# PARTIAL FIRST FLOOR PLAN

<b>CLIENT:</b> CHRIS MUNZ	<b>PROJECT:</b> MUNZ RESIDENCE	<b>DRAWING NUMBER:</b> 1 of 3	<b>SHEET:</b> S2
---------------------------	--------------------------------	----------------------------------	---------------------

# PARTIAL ROOF PLAN

<b>CLIENT:</b> CHRIS MUNZ	<b>PROJECT:</b> MUNZ RESIDENCE	<b>DRAWING NUMBER:</b> 3 of 3	<b>SHEET:</b> S4
---------------------------	--------------------------------	-------------------------------	------------------

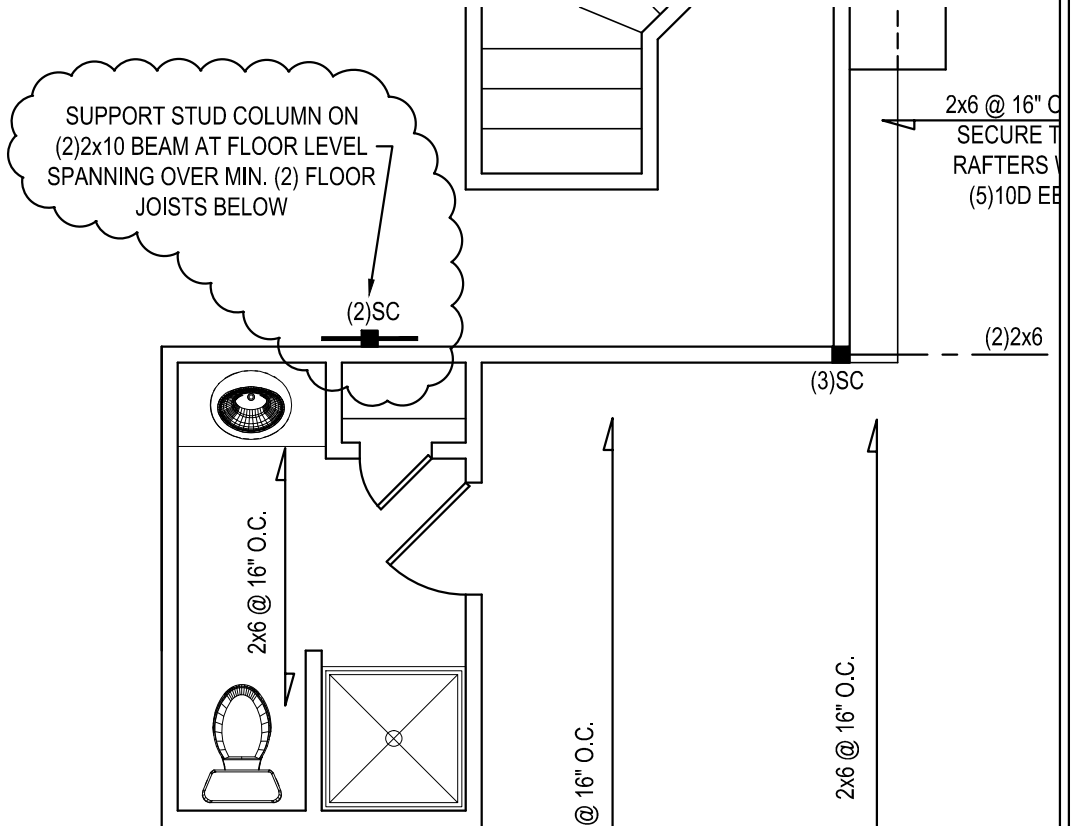
1) SUPPORTS ADDED FOR NEW POINT LOADS FROM DOUBLE RAFTERS

# PARTIAL SECOND FLOOR PLAN

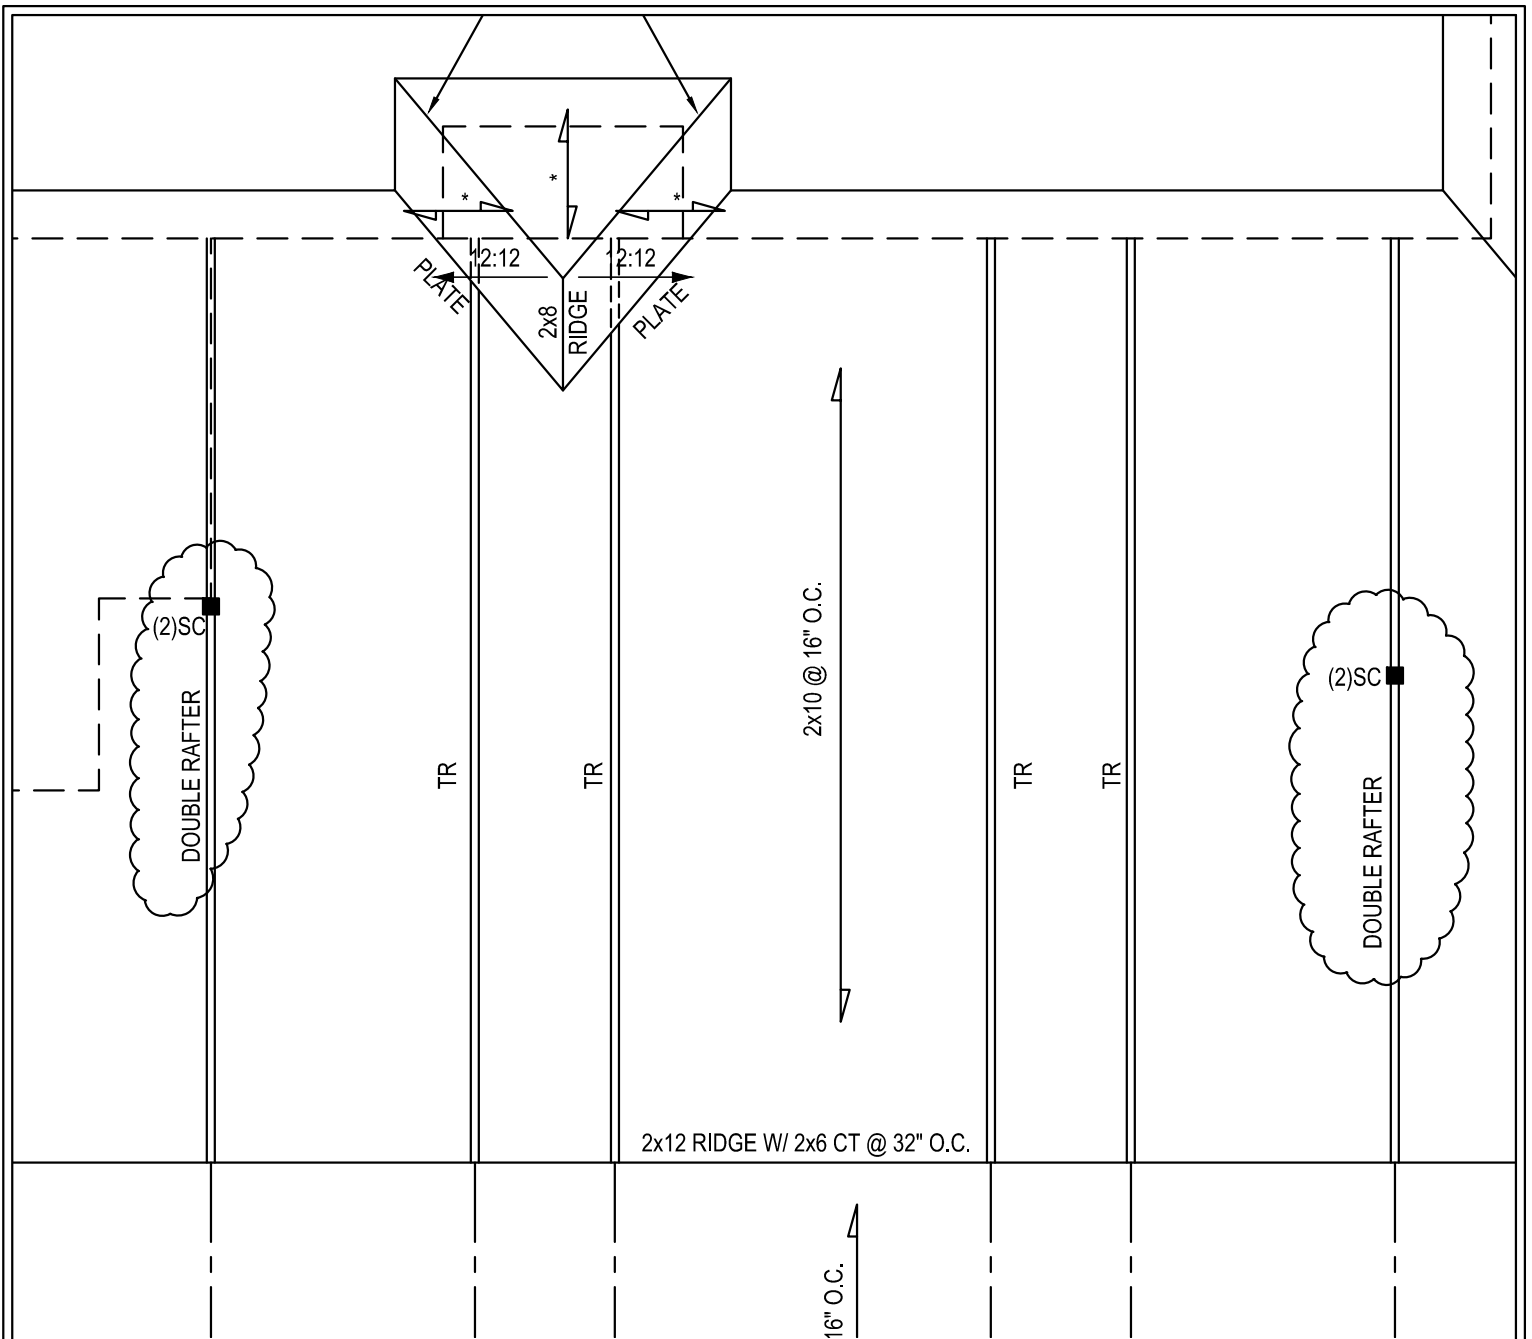
1) STUD COLUMN ADDED FOR SUPPORT OF DOUBLE RAFTER.
